## Product Change Notification: MFOL-31SHMS864

CCB 8110 Final Notice: Qualification of MTAI as an additional assembly site for selected MIC4426, MIC4420, MIC4423, MIC4429, MIC4425, MIC4427, MIC4424, and MIC4428 device families available in 8L SOIC (3.90mm) package.

**CCB 8110**  
**Pre and Post Change Summary**  
**PCN ID#: MFOL-31SHMS864**

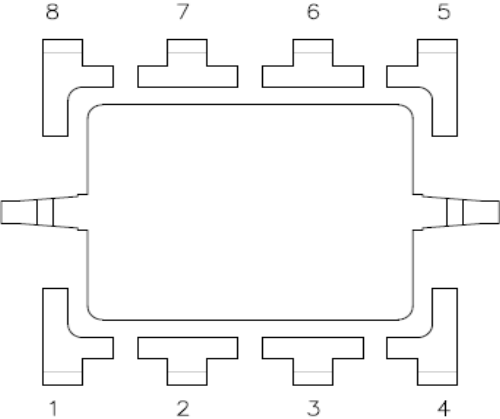
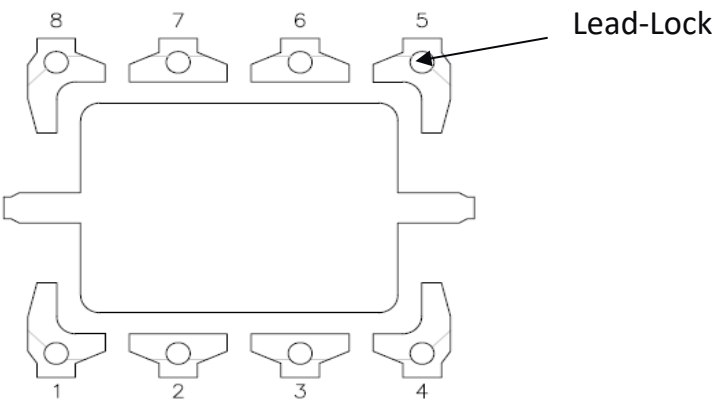
|               | Pre Change                        |                          | Post Change                       |                          |                               | Change<br>(Yes/No<br>) |
|---------------|-----------------------------------|--------------------------|-----------------------------------|--------------------------|-------------------------------|------------------------|
| Assembly Site | Stars Microelectronics (Thailand) | Unisem (M) Berhad Perak, | Stars Microelectronics (Thailand) | Unisem (M) Berhad Perak, | Microchip Technology Thailand | Yes                    |

|                                                     | Public Company<br>Limited (STAR)                           | Malaysia<br>(UNIS)     | Public Company<br>Limited (STAR) | Malaysia<br>(UNIS)     | (HQ)<br>(MTAI)               |     |
|-----------------------------------------------------|------------------------------------------------------------|------------------------|----------------------------------|------------------------|------------------------------|-----|
| <b>Wire<br/>Material</b>                            | Au                                                         | Au                     | Au                               | Au                     | CuPdAu                       | Yes |
| <b>Die<br/>Attach<br/>Material</b>                  | 2200D (PFAS)                                               | 8290<br>(PFAS<br>free) | 2200D (PFAS)                     | 8290<br>(PFAS<br>free) | CRM-<br>1064L<br>(PFAS free) | Yes |
| <b>Molding<br/>Compound<br/>Material</b>            | G600                                                       | G600KA                 | G600                             | G600KA                 | G634A                        | Yes |
| <b>Lead-<br/>Frame<br/>DAP<br/>Surface<br/>Prep</b> | NiPdAu                                                     | NiPdAu                 | NiPdAu                           | NiPdAu                 | Bare Cu                      | Yes |
| <b>Lead-<br/>Frame<br/>Lead<br/>Lock</b>            | No                                                         | No                     | No                               | No                     | Yes                          | Yes |

# Pre and Post Summary – Lead Frame Comparison

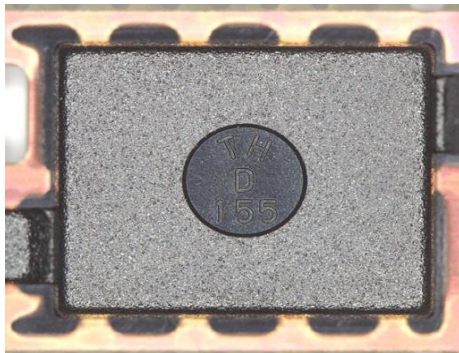
| STAR and UNIS                                                                                                                                                                                                                                                                                                | MTAI                |              |                             |        |                      |    |                                                                                                                                                                                                                                                                                                               |                     |         |                             |         |                      |       |
|--------------------------------------------------------------------------------------------------------------------------------------------------------------------------------------------------------------------------------------------------------------------------------------------------------------|---------------------|--------------|-----------------------------|--------|----------------------|----|---------------------------------------------------------------------------------------------------------------------------------------------------------------------------------------------------------------------------------------------------------------------------------------------------------------|---------------------|---------|-----------------------------|---------|----------------------|-------|
| <div><p>Note: Not to scale</p></div> <table><tr><td>Lead-Frame Material</td><td>C194 / A194*</td></tr><tr><td>Lead-Frame DAP Surface Prep</td><td>NiPdAu</td></tr><tr><td>Lead-Frame Lead Lock</td><td>No</td></tr></table> | Lead-Frame Material | C194 / A194* | Lead-Frame DAP Surface Prep | NiPdAu | Lead-Frame Lead Lock | No | <div><p>Note: Not to scale</p></div> <table><tr><td>Lead-Frame Material</td><td>CDA194*</td></tr><tr><td>Lead-Frame DAP Surface Prep</td><td>Bare Cu</td></tr><tr><td>Lead-Frame Lead Lock</td><td>Yes**</td></tr></table> | Lead-Frame Material | CDA194* | Lead-Frame DAP Surface Prep | Bare Cu | Lead-Frame Lead Lock | Yes** |

Note:\*\* Mold compound materials fills the leadlock hole, which provides improved protection against moisture penetration along the edge of the leads (pins) of the package.
